### Introduction

1. Oxfordshire County Council responded to Thames Water's Draft Water Resource Management Plan (WRMP) in April 2018. The full response is contained in Appendix 2.
2. In July 2018, Oxfordshire County Council resolved to support the position of Group Against Reservoir Development (GARD) in their response to the Draft WRMP19 which asked Thames Water to undertake a second consultation and to:
  - a. Reduce leakage by half by 2050
  - b. Improve water-use efficiency to match the norms of other companies
  - c. Provide a proper analysis of water available through other measures, including Teddington DRA and water re-use.The full response is contained in Appendix 3.
3. The following comments are in response to Thames Water's Revised Draft WRMP published in October 2018.

**Map 1: 'Big Ticket' schemes**

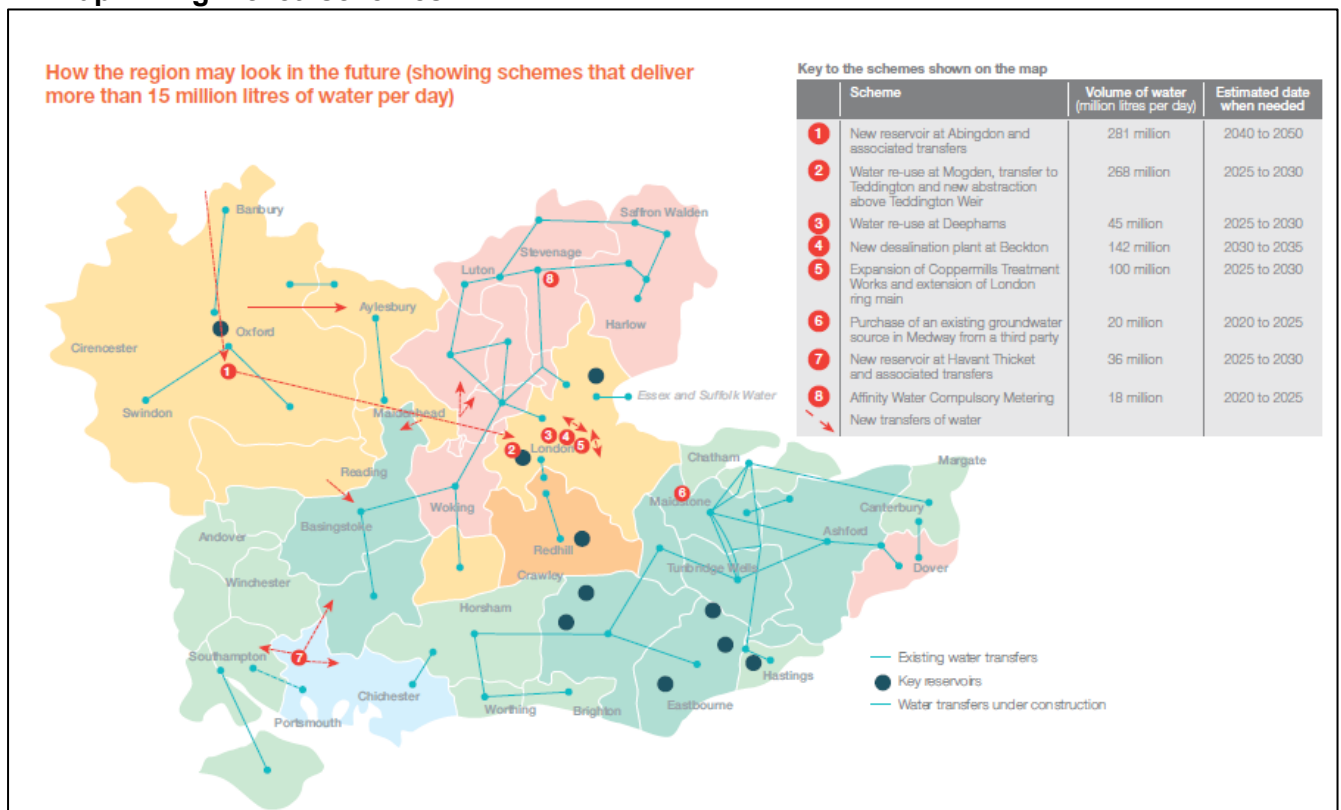
10. It is not clear from the WRSE Strategy whether water companies have collectively reviewed potential schemes across the south-east and reached a conclusion on the best option for all water companies and consumers, or if the proposed reservoir in Oxfordshire is simply presented by Thames Water as a 'good choice' for the south-east.

**Map 2: 150Mm3 reservoir option**

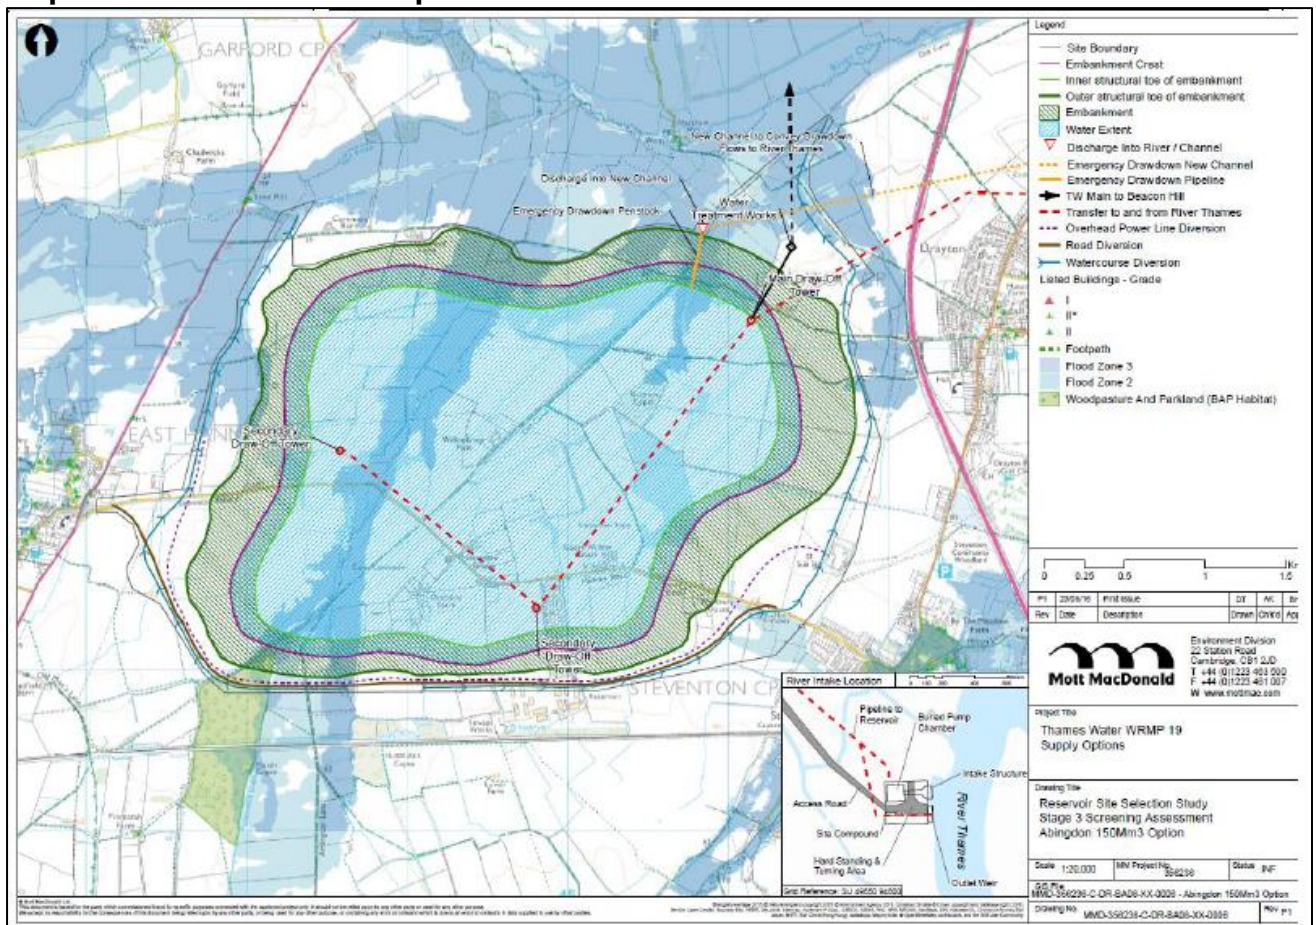
22. Oxfordshire County Council understands that that the various plans/maps within the report are concept only and that further work is required on these. However, they do raise a number of issues which OCC would seek clarity on

moving forward. Some of the issues raised below will have a material impact on whether the Abingdon Site can be delivered in terms of infrastructure required outside of the site. Below are the main issues we wish to raise.

23. OCC seeks clarity on the intended road access for the site. In *Appendix D: Stage 2: Site assessment*, the RAG assessment of the Abingdon site (p.36) states that “Site access does not involve local roads – access to A34 via A415 without the need to pass through built up areas”, this would appear to be confirmed by the site layout drawings in *Appendix U: Abingdon phased options*, which indicate an access road from the site joining the A415 to the west of the Marcham Interchange.

24. However, this would appear to be inconsistent with the wording in *Appendix M: Reservoir site descriptions*, in which access for each capacity option is described as “Road access to the site would be provided by a new access off the A34 road on the eastern end of the reservoir.” OCC seeks confirmation whether it is intended for the access road to be from the A415 or directly from the A34 itself.
